Transportation Impact Assessment

Blackstone South Condo Development

TIA Report

The following transportation-related comments were received by the City of Ottawa (April 29, 2019) in response to the Step 3 Blackstone Condo Development submission dated April 15, 2019. Responses to these city comments are provided herein.

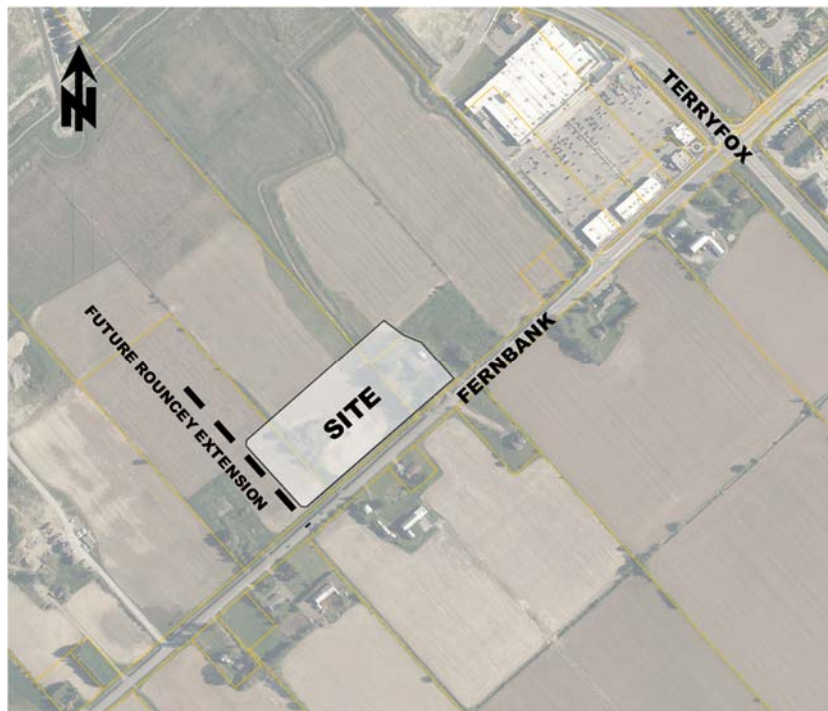
Comment 6: While the fire route is depicted, no turning movements are shown on the site plan.

Comment 9: The site plan shows 108 total units instead of 216.

Response 6: *See attached plan displaying Fire Truck (HSU) movements throughout site.*

Response 9: The site plan has been updated to reflect the statistics of both phases of development which consist of 108 units each (totaling 216 units).
